Title - Sujet Aménagement, 4e étage, Moncton (Pat	
Solicitation No. - N° de l'invitation EC096-183244/A	Amendment No. - N° modif. 001
Client Reference No. - N° de référence du client R.083347.002	Date 2018-05-03
GETS Reference No. - N° de référence de SEAG PW-\$PWJ-012-5393	
File No. - N° de dossier PWJ-8-41002 (012)	CCC No./N° CCC - FMS No./N° VME
Solicitation Closes - L'invitation prend fin at - à 02:00 PM on - le 2018-05-08	Time Zone Fuseau horaire Atlantic Daylight Saving Time ADT
F.O.B. - F.A.B. Plant-Usine: <input type="checkbox"/> Destination: <input checked="" type="checkbox"/> Other-Autre: <input type="checkbox"/>	
Address Enquiries to: - Adresser toutes questions à: Martin (PWJ), Lisa M.	Buyer Id - Id de l'acheteur pwj012
Telephone No. - N° de téléphone (506) 962-5328 ()	FAX No. - N° de FAX (506) 851-6759
Destination - of Goods, Services, and Construction: Destination - des biens, services et construction:

Modification numéro 1

CANADIAN HERITAGE
4th FLOOR FIT-UP
1045 MAIN STREET
MONCTON NB

COMPOSITE &
DEMOLITION PLAN

ID 1.0

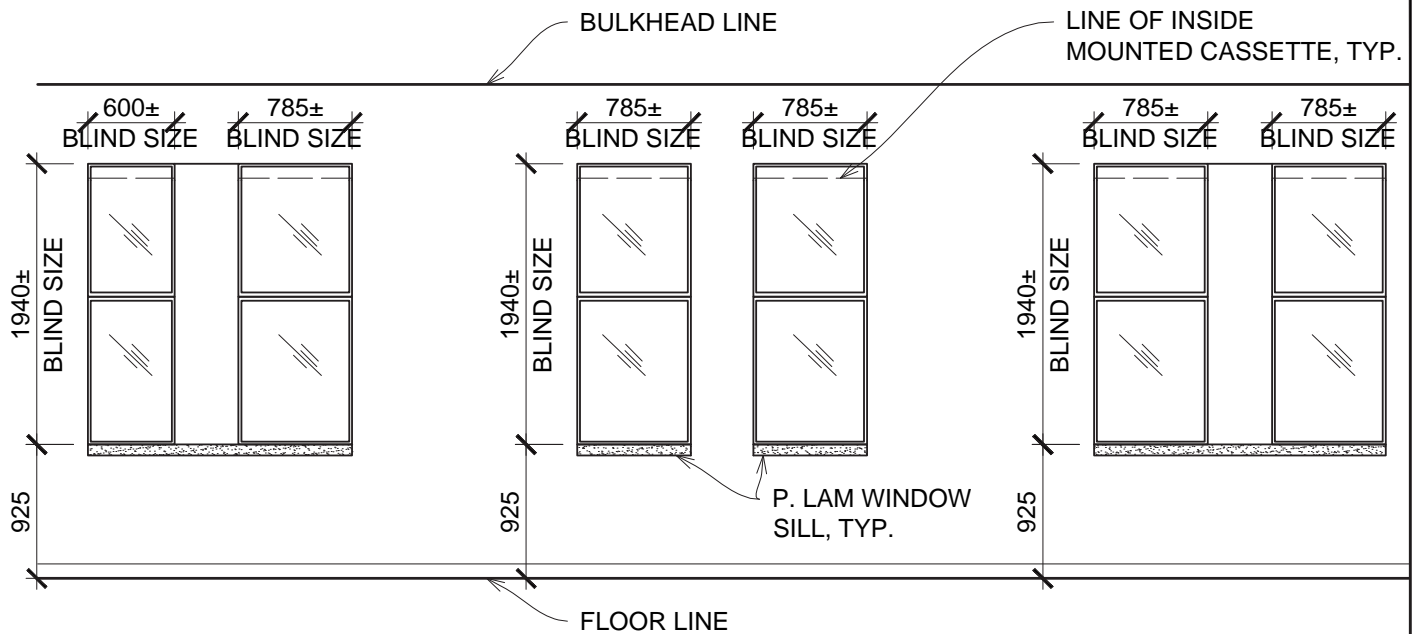
On drawing ID 1.0 it shows the demolition drawing and scope of work but at the site visit it was noticed that most of the demolition has already been done. Please clarify if there is any demolition required in this contract?

At the site visit it was noticed that there was terrazzo floor remaining that is higher in elevation than the existing top of slab. Please clarify what happens with the terrazzo flooring.

- .1 Refer to Drawing ID 1.0 – Composite & Demolition Plan
 1. Replace drawing ID 1.0 with attached, revising scope of demolition.
- .2 Refer to Drawing ID 1.1 – Construction & Reflected Ceiling Plan

Demolition scope revised, see ID 1.0 Rev 1 attached to Addendum No 1

Terrazzo will be removed, see ID 1.0 Rev 1 attached to Addendum No 1

SK-1

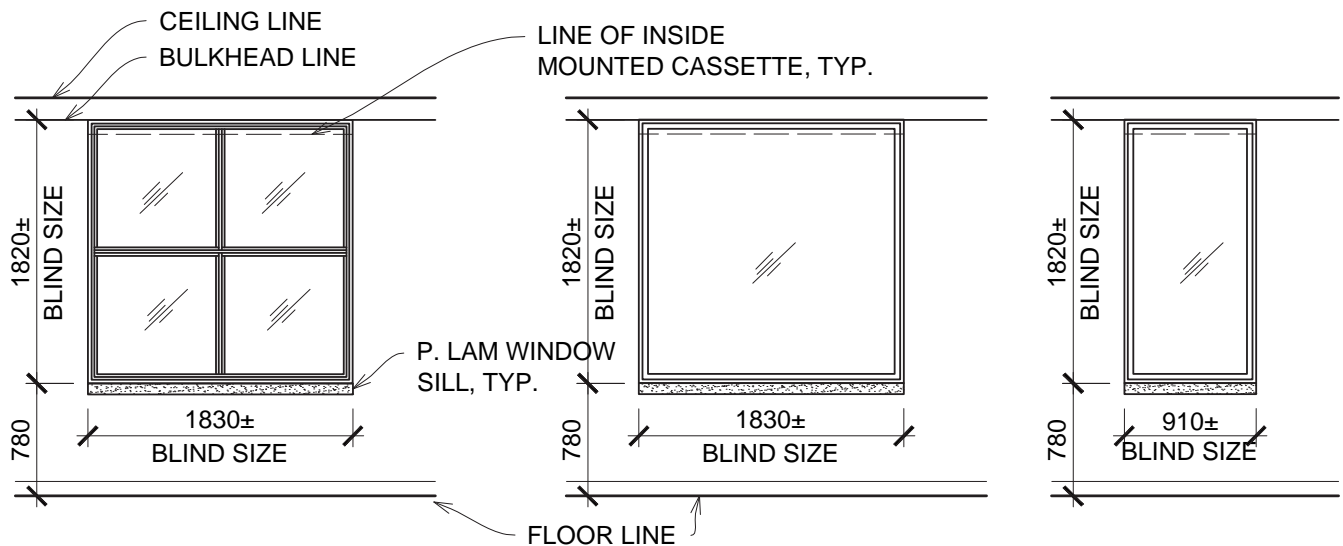
Also, can you confirm the height of all the windows that require window treatments?

1. Revise Key Note 1 on Construction Plan to read - Key Note 2 in Medium Meeting Room 4521 and Small Meeting Room 4532.
 2. Add SK-1 drawing attached for window treatment and sill sizes

See SK-1 attached to Addendum No 1
